## Application for Licence Amendment

| <b>Licence Number</b> | L5107/1988/13  |
| <b>Licence Holder</b> | Northern Star (HBJ) Pty Ltd  |
| <b>Premises</b>       | Jubilee Gold Mine<br><br>Legal description -<br><br>Lot 15 on Plan 58833, Lot 50 on Plan 226299 and Lot 51 on Plan 226303, Feysville, Lot 103 on Plan 40395 Lot 105 on Plan 40396, Karamindsie, and mining tenements M26/118, M26/143, M26/204 and M15/456 |

**Figure 3: Jubilee TSF and surrounding monitoring and seepage recovery bores**

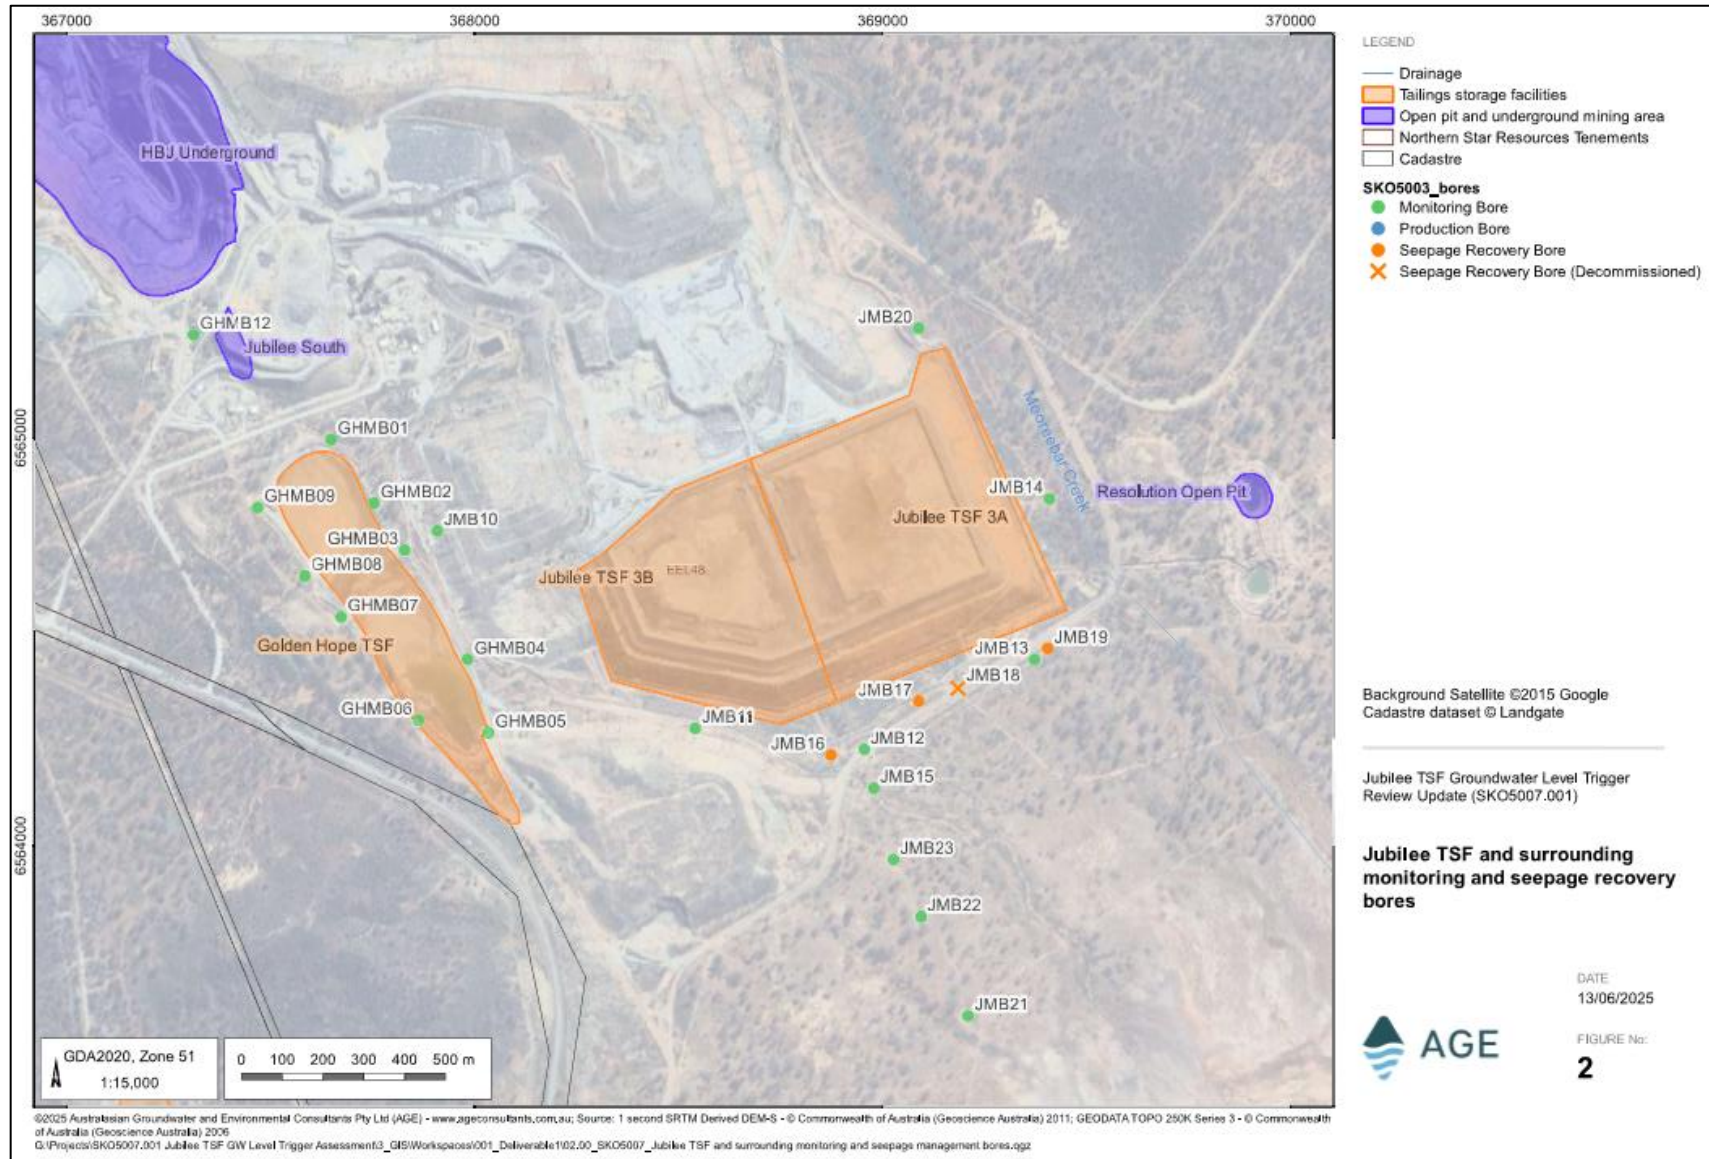
The licence holder has requested to lower the groundwater level trigger from 4 m bgl to 2 m bgl for monitoring bores JMB10, 12 to 15 and 21 to 23 surrounding the Jubilee TSF. The location of these bores is shown in Figure 3.

The licence holder has proposed this change due to frequent exceedance of the current limit as a result of reduced abstraction rates surrounding the Jubilee TSF since the Jubilee Processing Plant went into care and maintenance in August 2022.

Historically, groundwater levels in bores around the Jubilee TSF began rising during mid to late 2020 and continued through 2021. In 2021, the first exceedance of the current 4 m bgl standing water level (SWL) limit specified in the licence occurred. At the time, pumping strategies and management measures were implemented and groundwater levels began to decline. When the facility went into care and maintenance and abstraction decreased, groundwater levels in more bores began to rise again. Consequently, the 4 m bgl limit has been exceeded consistently in some bores since. A summary of the exceedances is shown in Table 5.

The delegated officer acknowledges that the licence holder has requested to lower the standing water level trigger limit, as the current 4 m bgl limit can no longer be maintained in all bores due to decreased seepage abstraction rates as a result of the processing plant being in care and maintenance and a lower onsite demand for water. The delegated officer notes that the existing limit could likely be met if abstraction rates were increased to pre-July 2022 levels.

The delegated officer also acknowledges that, to date, there has been no observed decline in vegetation health. However, the delegated officer does not consider the current lack of visible impact sufficient evidence to justify that there lowering the limit will not result in decline in vegetation health, or, vegetation death. Vegetation death is considered a significant environmental impact.

Typically, the department applies a limit of 4 m bgl to protect the root zones of most species. The root zones of *Maireana sedifolia* and *Maireana villosa* may extend to approximately 2 m deep. The delegated officer considers that if the limit is lowered to 2 m bgl, there is a possibility that these species may be impacted.

In considering these findings, the delegated officer has amended the limit to 2.5 m bgl to ensure the protection of all native vegetation species within the vicinity of the Jubilee TSF and to allow for a 0.5 m buffer between groundwater and the estimated root zones.

**Figure 4: Jubilee TSF monthly seepage abstraction (AGE, 2025)**

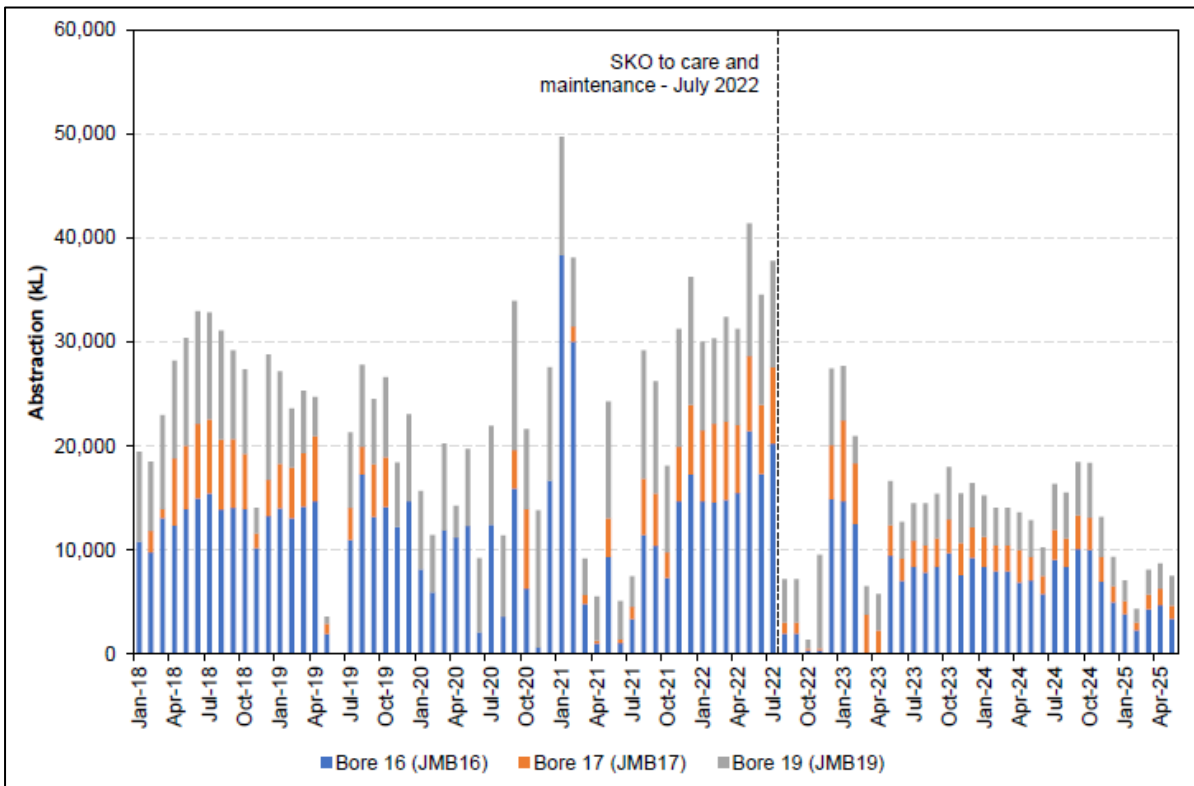
The Jubilee processing plant went into care and maintenance in August 2022 and deposition of tailings into the Jubilee TSF has ceased. Historically, seepage and mounding from the Jubilee TSF has been managed through abstraction from seepage recovery bores (JMB16, 17 and 19).

Since July 2022, the rate at which seepage has been recovered from the bores has decreased as there has been a decreased demand for processing water. Figure 4 shows abstraction rates from the seepage recovery bores noting a 45% decrease in abstraction since the processing plant / TSF went into care and maintenance (AGE, 2025). Seepage abstraction is currently directed to the operating site Duckpond and Location 51 where water is used for underground mining, dust suppression, drilling, washdown facilities and storage.
